**OHIO TURNPIKE AND
INFRASTRUCTURE COMMISSION**

ADDENDUM NO. 1

SERVICE PLAZA RENOVATIONS

**CHANGES TO PLAN DRAWINGS
Sheet Number 6-A4.0, 6-A7.6, 6-8.1, 7-AS1.0 and 7-A8.1**

SP-6 Great Lakes & Towpath

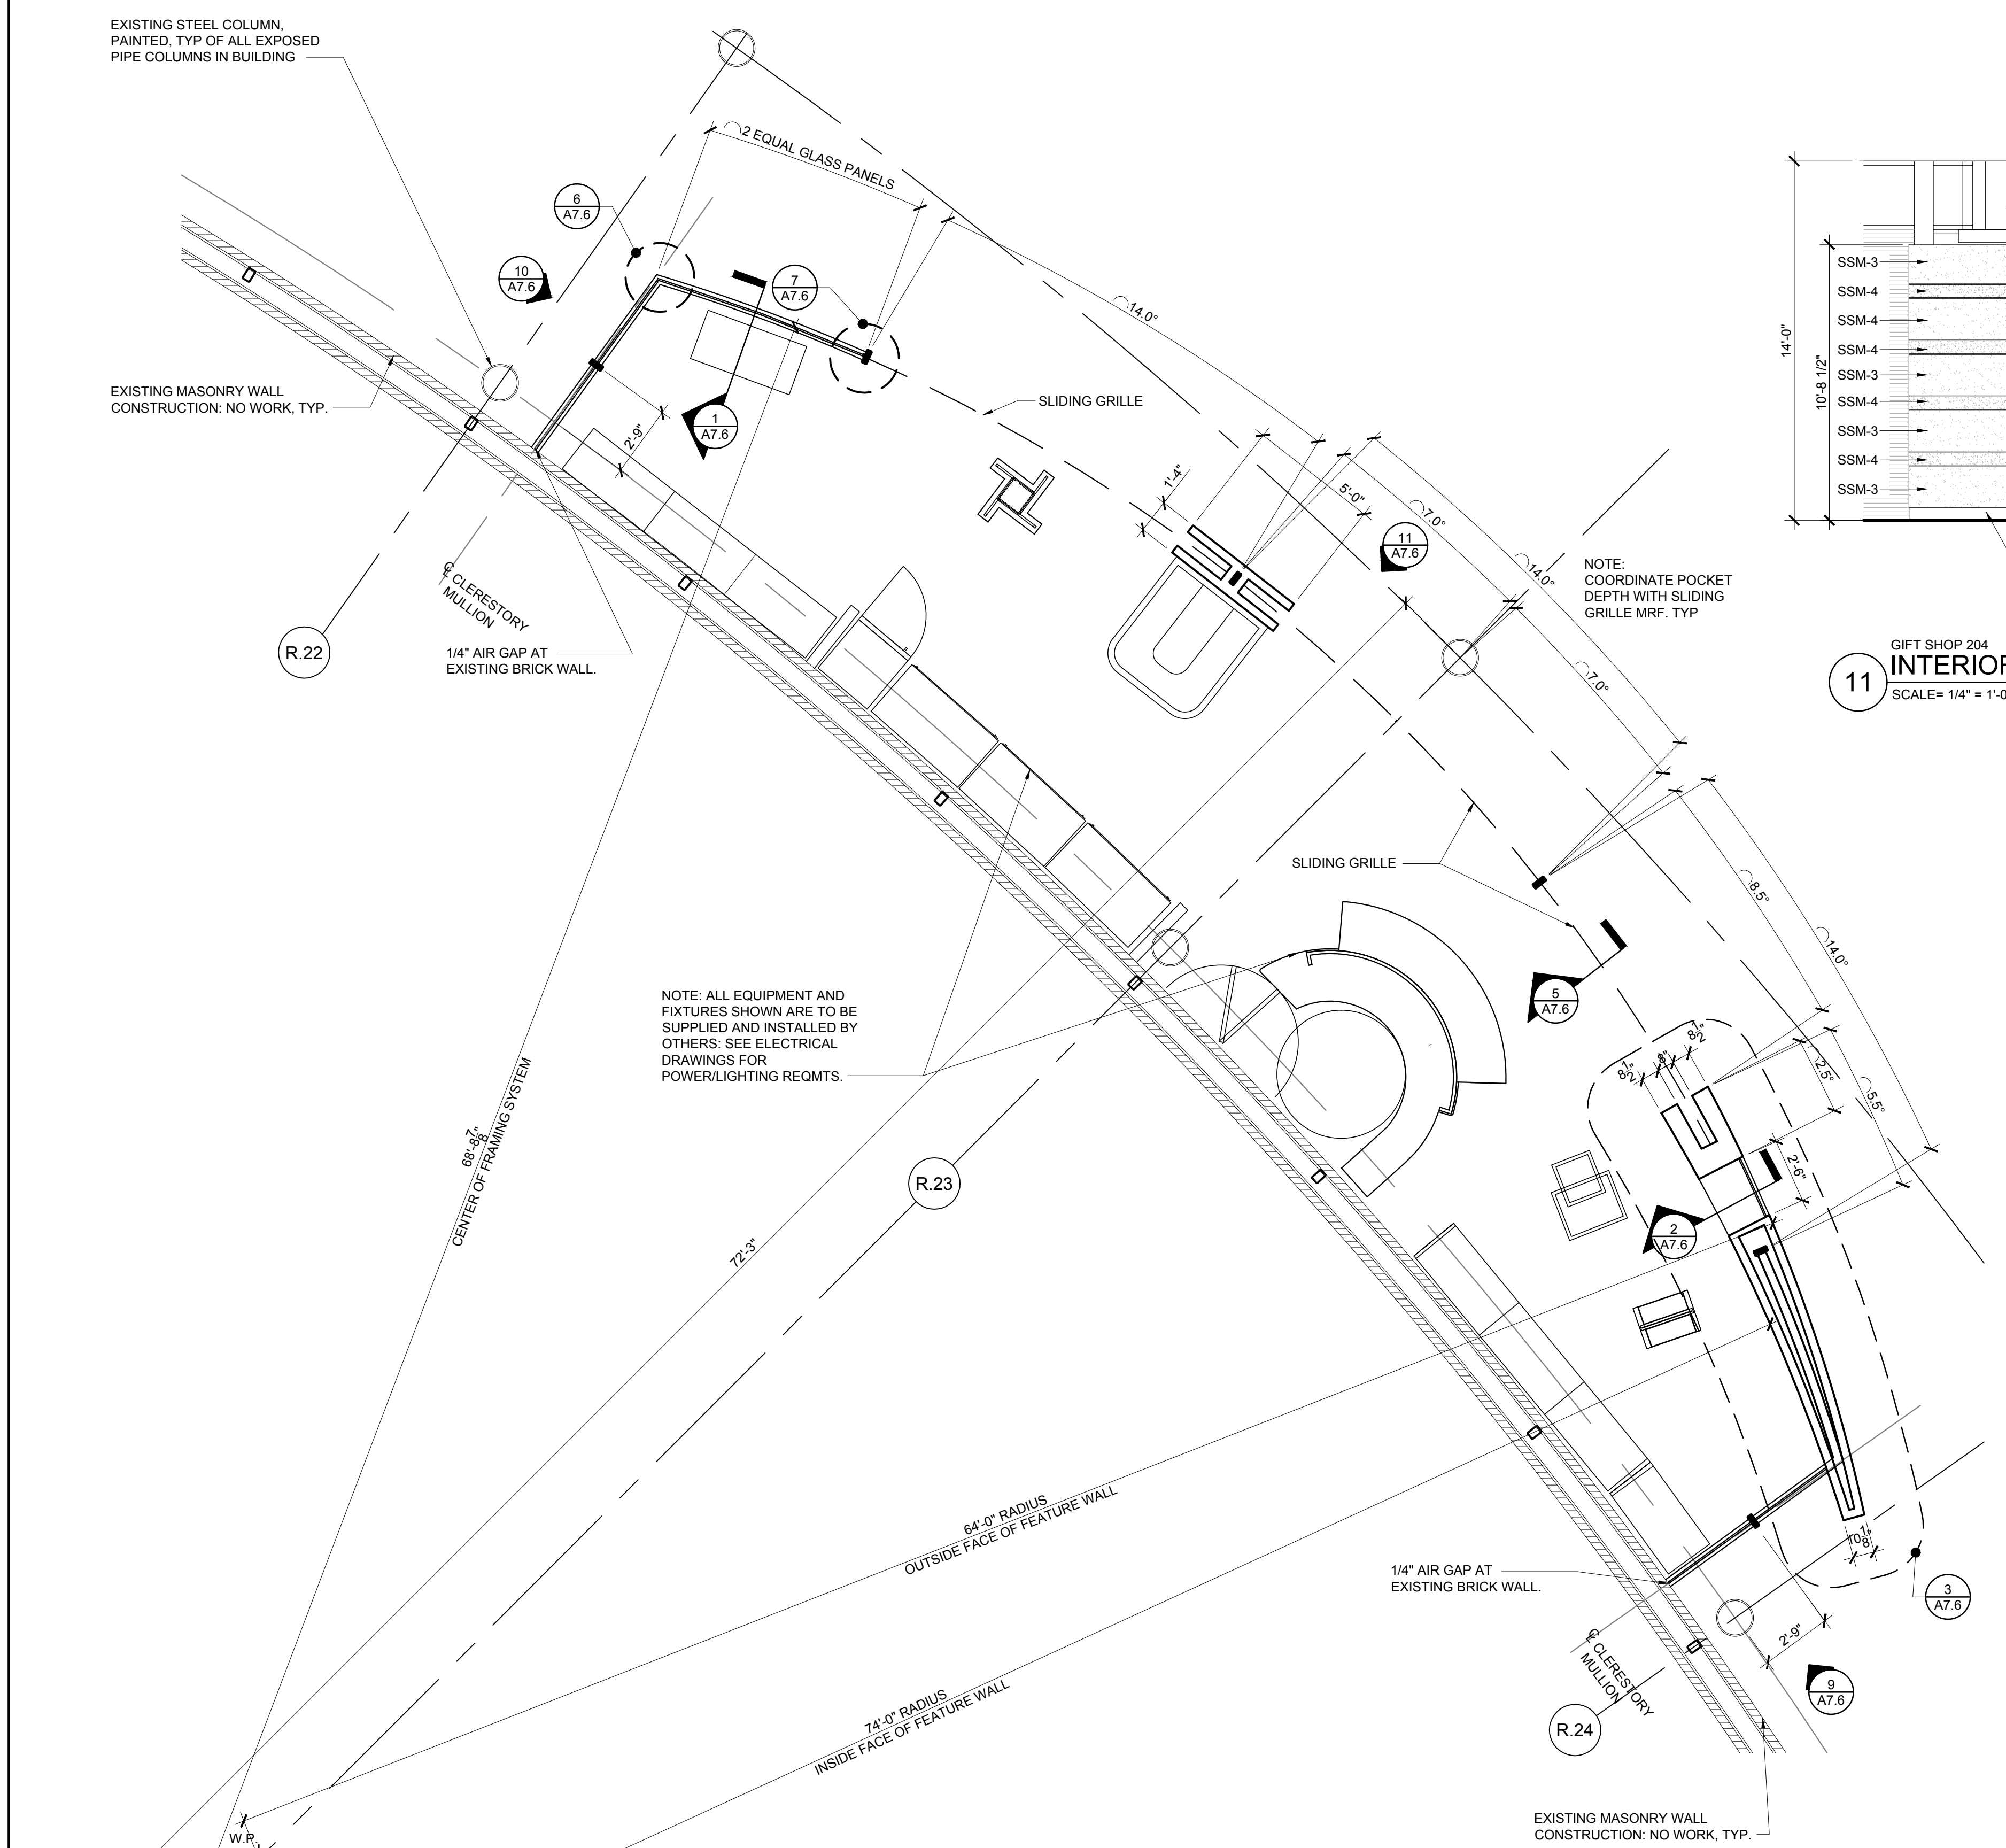
Q#11 Wall section 2 on 6-A7.6 shows a 6"H x 5/8" Dia. stainless steel base and 6"H x 7/8" Dia. stainless steel base. Please clarify what these items are.

A#11 The base dimensions should read 6"H x 5/8" Deep and 6"H x 7/8" Deep. This affects 6.A7.6 Plan Sheet.

6-A8.1

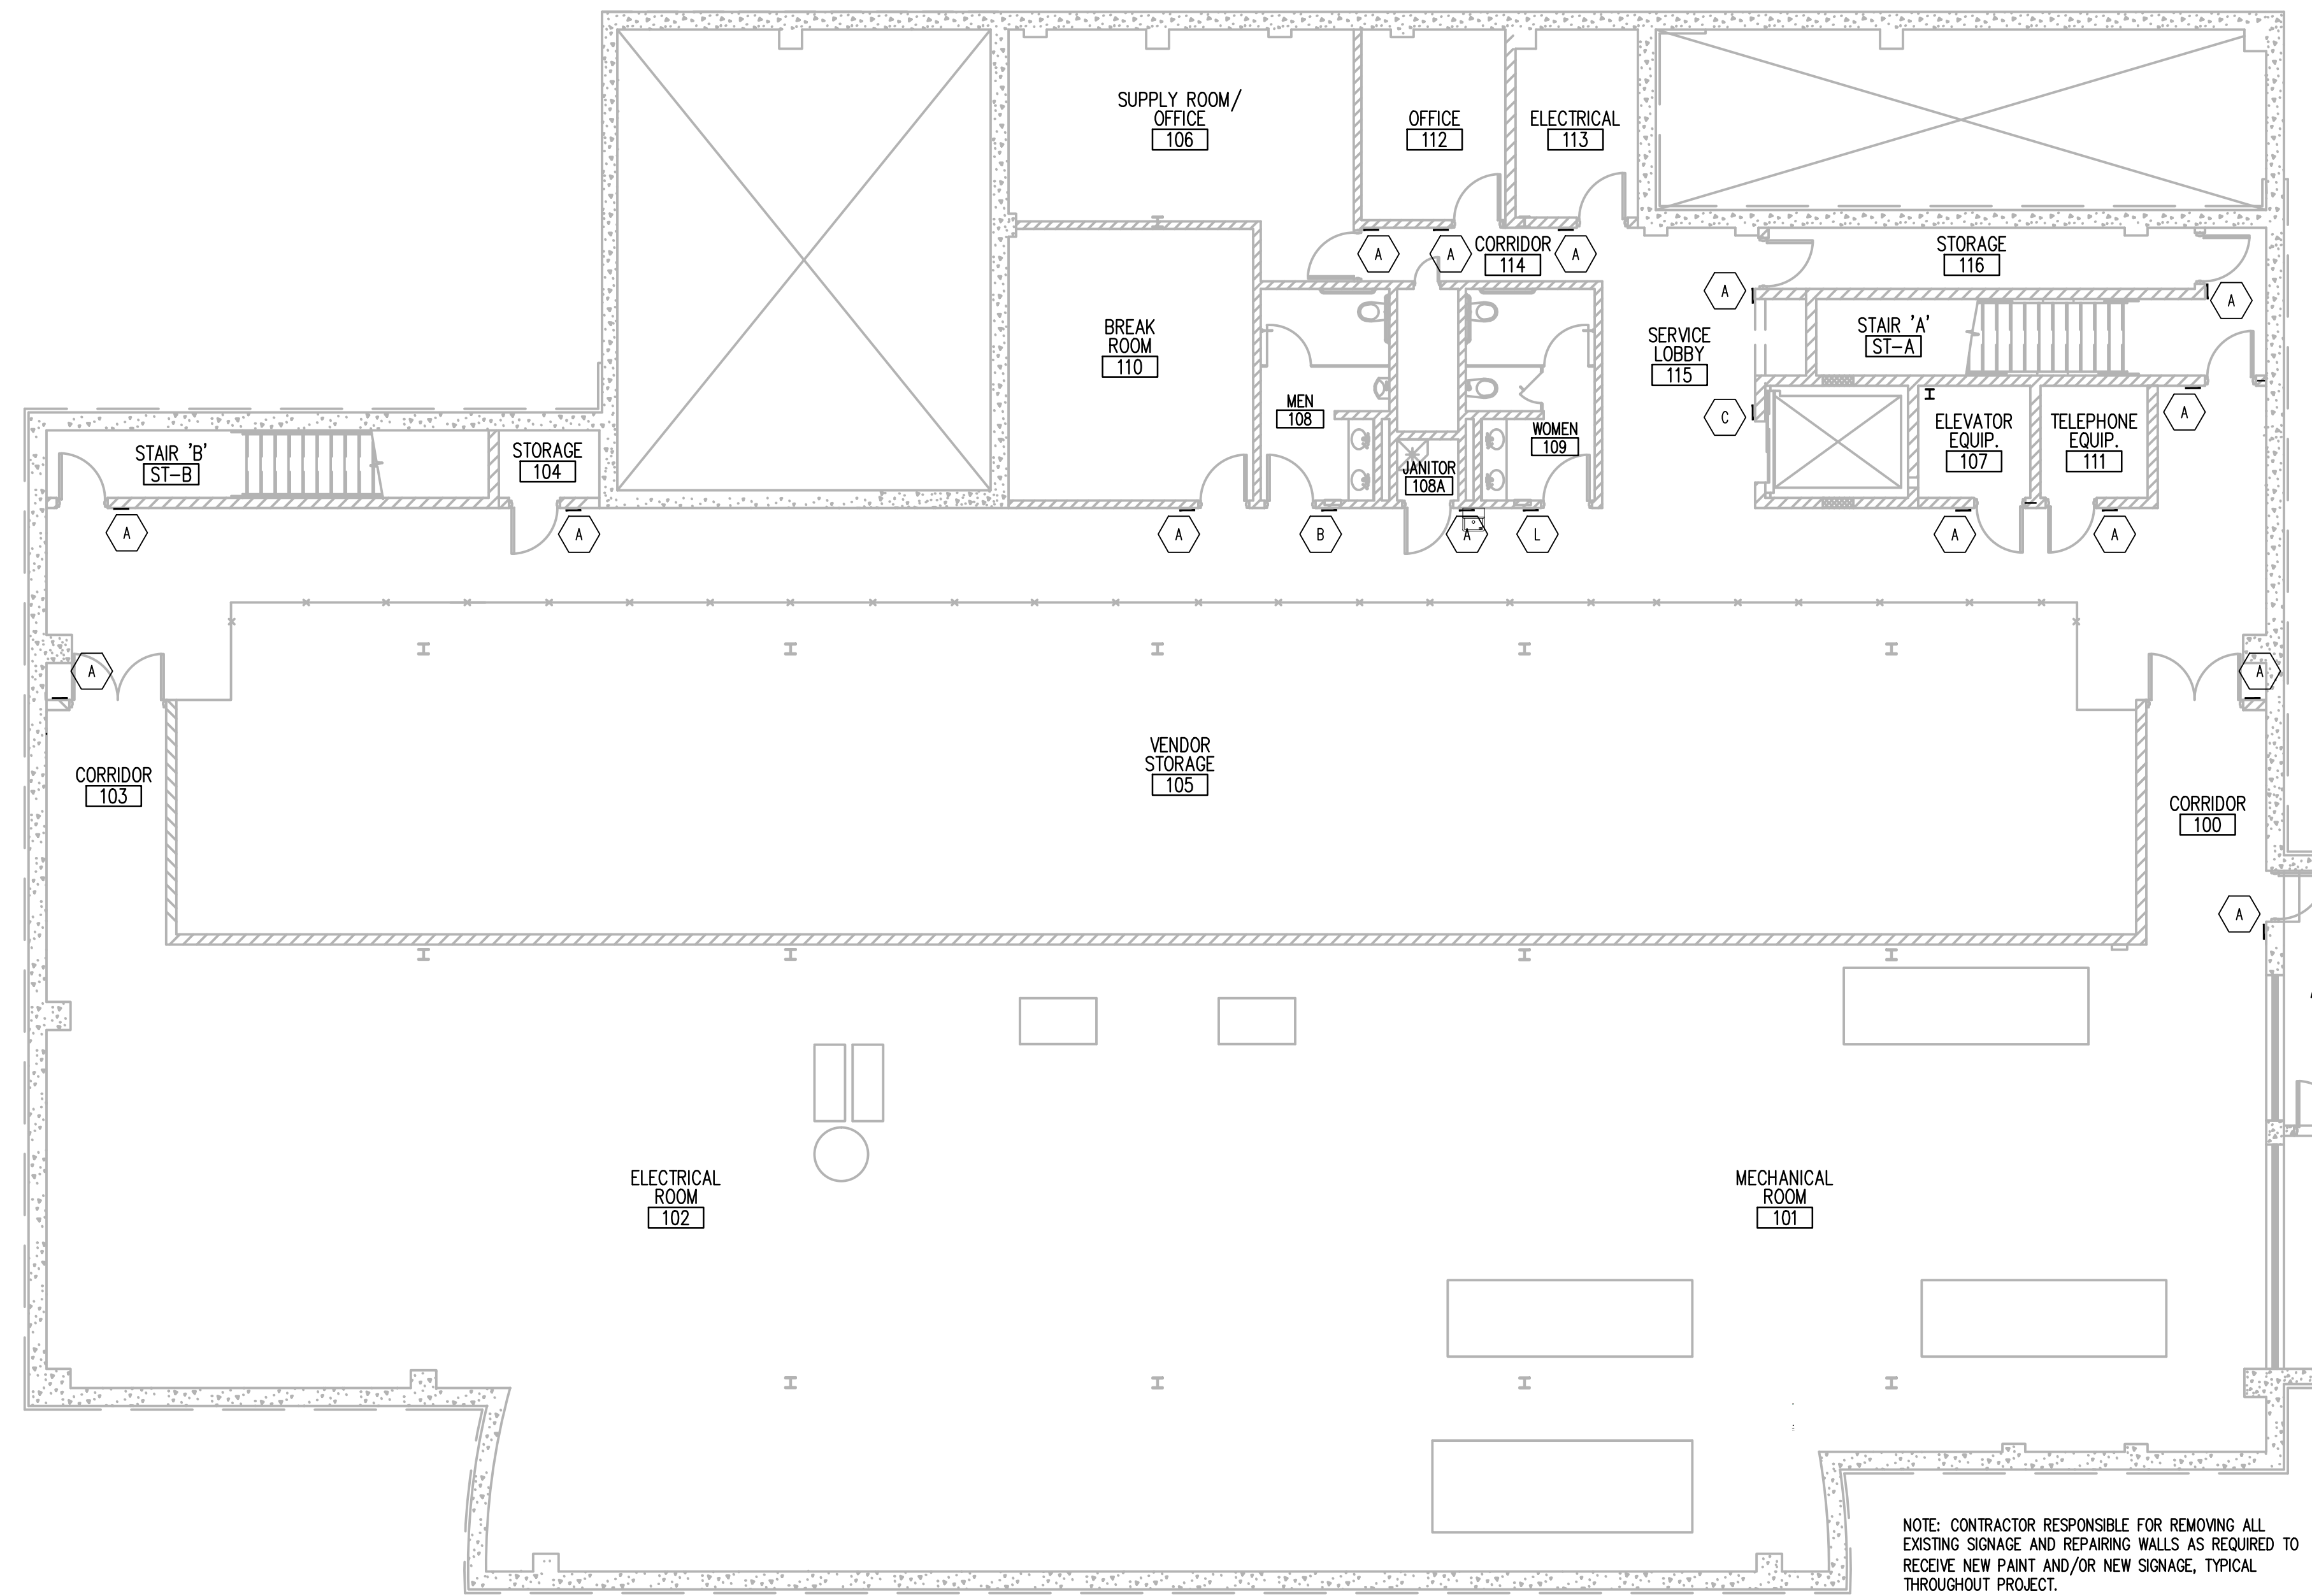
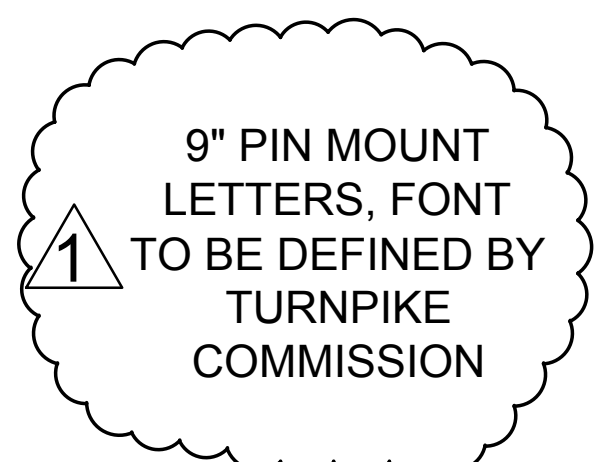
Q#7 Regarding Dimensional Letters: On the Signage Plan, for "Sign Type N", 12" height is stated; but in the "General Notes", 9" is specified. Please clarify the desired height for the dimensional letters.

A#7 Sign Type N letters are to be 9-inches in height. This clarification affects 6-A8.1 and 7-A8.1 Plan Sheets.

TYPESTYLE OF SIGN TYPE "N" LETTERS TO BE HUMANIST 521BT - FINAL LAYOUT AND TYPESET TO BE APPROVED BY ARCHITECT PRIOR TO INSTALLATION. COLOR TO MATCH SHERWIN WILLIAMS SW6545 MAJESTIC PURPLE. SEE DWG. ASS1 AND ARCH DWGS. FOR LOCATIONS OF SIGN TYPE "N". CAPITOL LETTERS TO BE 9" IN HEIGHT AND ALL LETTERS TO BE 3/8" THICK, TYP.
